SOUTH FRANKLIN
WATER LINE IMPROVEMENTS
CONTRACT NO. RFQ E10-229

Addendum No. 21 of 3

Addendum No. 1

NEW PIPING PLAN

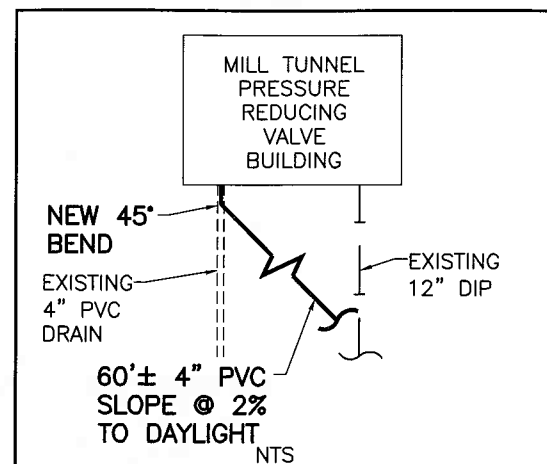
NOTE:
VALVES IN SOUTH FRANKLIN STREET TO BE INSTALLED SO THAT THEY ARE VERTICAL

ROLL TEE AND 90° SO THAT NEW 12" DIP BYPASS PIPE CROSSES UNDER EXISTING LINE. PROVIDE ALL FITTINGS, ADAPTERS ETC., NECESSARY TO CONNECT TO EXISTING PIPING.

APPROX. PAVEMENT REMOVE/ REPLACE LIMITS, REMOVE EXISTING PAVEMENT AND REPLACE W/ 12" D-1 & 6" AC PAVEMENT. SIMILAR TO CBJ STANDARD DETAIL 125
